1.0 APPLICATION SUMMARY

Applicant: Abacus Farms, LLC
FLU Category: SMU-6 (Suburban Mixed Use – 6)
Service Area: Urban
Site Acreage: 6.23
Community Plan Area: Ruskin
Overlay: None

AGENCY REVIEW COMMENT SHEET

2.5 Proposed Site Plan (partial provided below for size and orientation purposes. See Section 8.2 for full site plan)

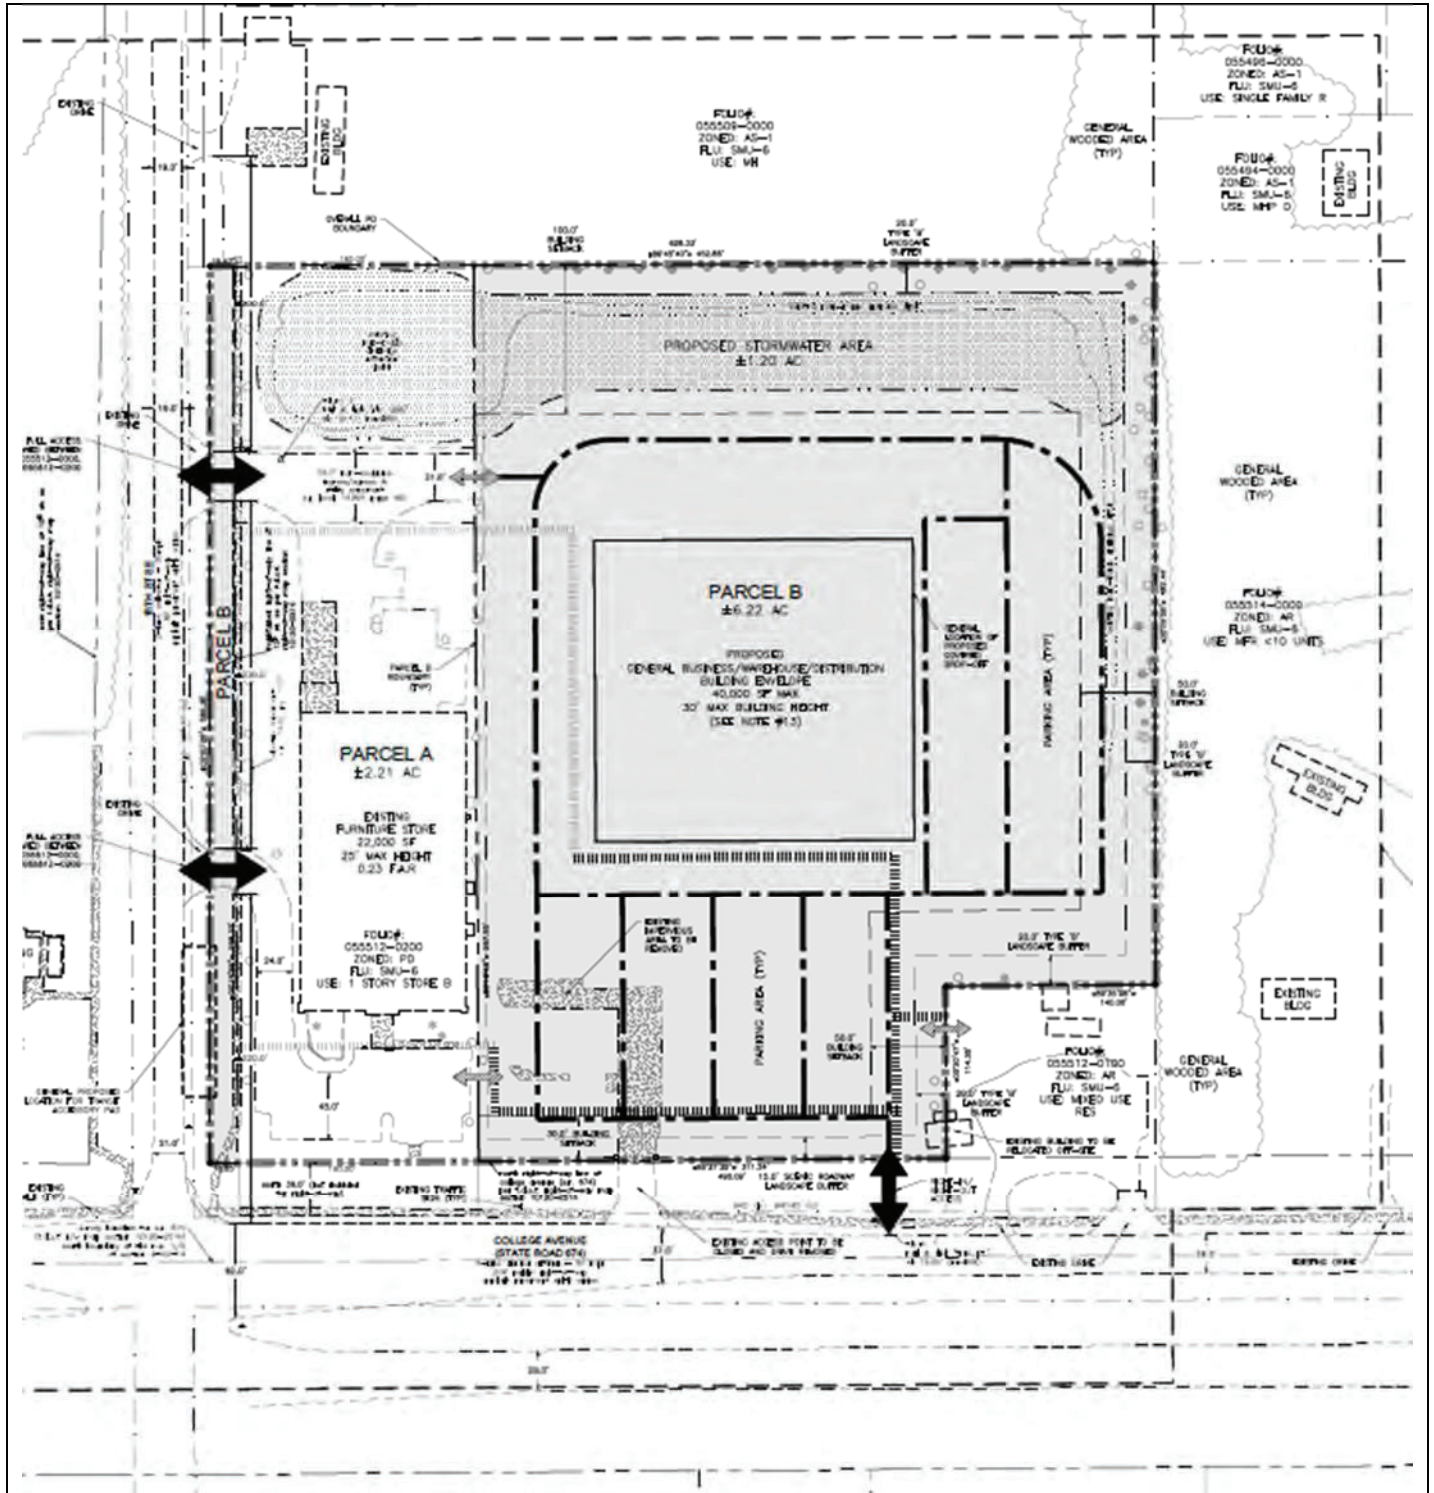
1.2 Parcel B – ~~50,000~~ 40,000 square feet for an office/warehouse (minor industry only), with the option for Commercial, General (CG) uses, excluding outdoor storage and major vehicle repair, Retail (Shopper’s Goods), warehouse, and distribution uses such that no more than 20,000 square feet of Retail (Shopper’s Goods) or 25,000 square feet of warehouse and distribution use shall be permitted within the 40,000 square footage. Drug stores, drinking establishments, and drive-through facilities shall not be permitted. The covered drop-off area noted on the site plan is permitted.

8.2 Proposed Site Plan (Full)

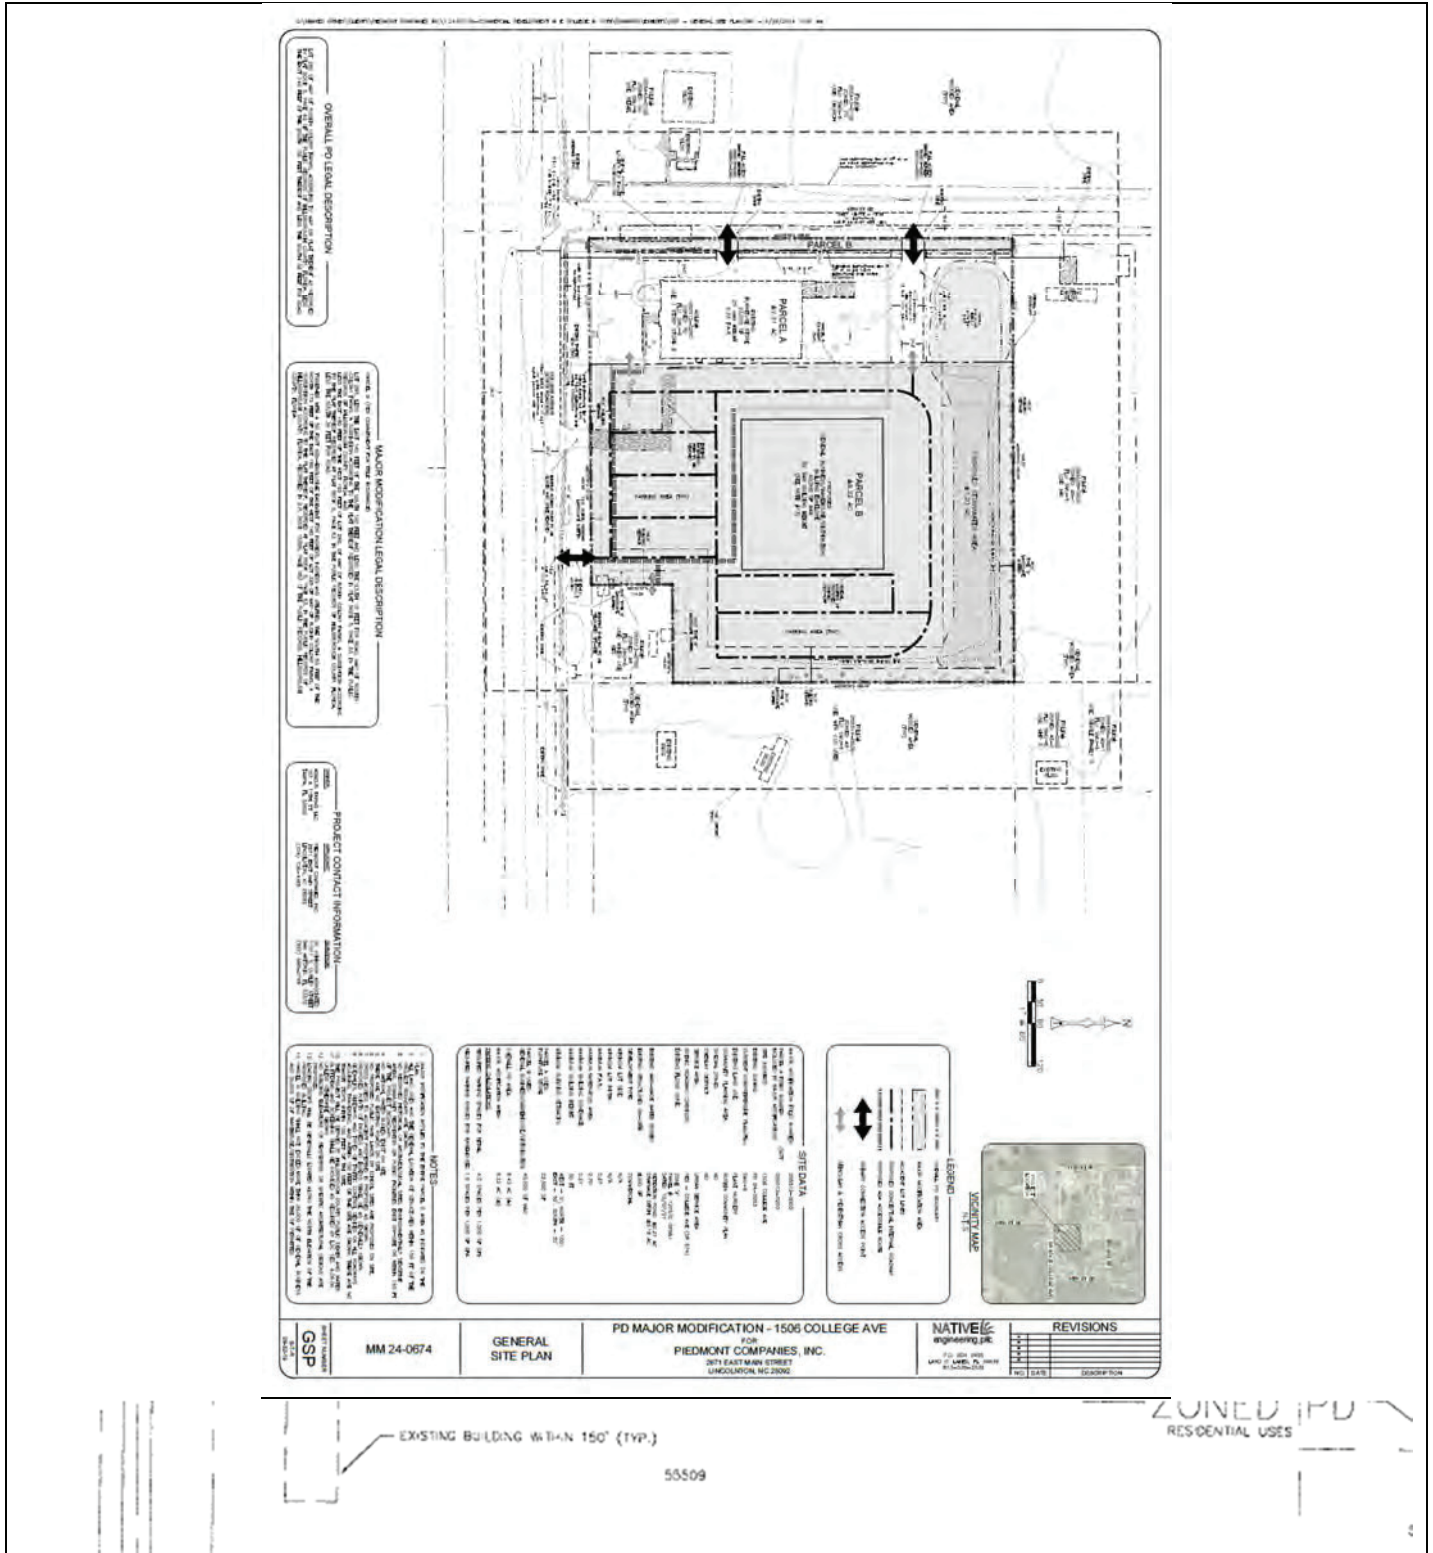
- 1. Revise the Label “Proposed General Business/Warehouse/Distribution Building Envelope” to Proposed Retail (Shopper’s Goods)/Warehouse/Distribution Building Envelope”.
- 2. Revise the Label “General Proposed Location for Transit Accessory Pad” to “General Proposed Location for Transit Facilities – See Conditions of Approval”.
- 3. Revise maximum FAR from 0.27 to 0.17.

- Prior to PD Site Plan Certification, the developer shall revise the PD site plan to:
 - Revise the Label “Proposed General Business/Warehouse/Distribution Building Envelope” to Proposed Retail Shopper’s Goods/Warehouse/Distribution Building Envelope”.
 - Revise the Label “General Proposed Location for Transit Accessory Pad” to “General Proposed Location for Transit Facilities – See Conditions of Approval”.
